PARTS INFORMATION

BMW E28 5 Series & E24 6 Series

Part #'s 11 81 1 128 932 and 11 81 1 175 735

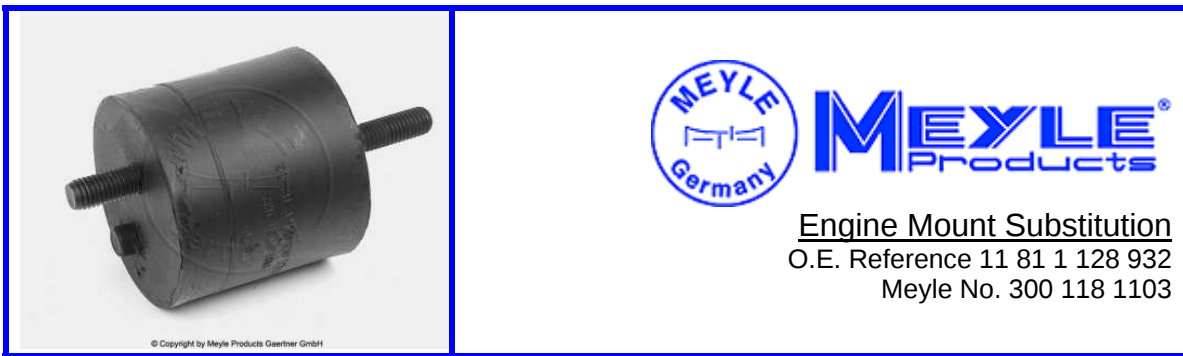
The 11 81 1 175 735 a relatively softer mount has been discontinued by Meyle and has been superseded to the cylinder style high performance version mount part number 11 81 1 128 932.

The cylinder style mount although designed differently will fit perfectly into all E28 and E24 version applications and will last longer and perform better than the older "V" style motor mount.

"V" style motor mount
11 81 1 175 735
discontinued

cylinder style mount
11 81 1 128 932
replacement
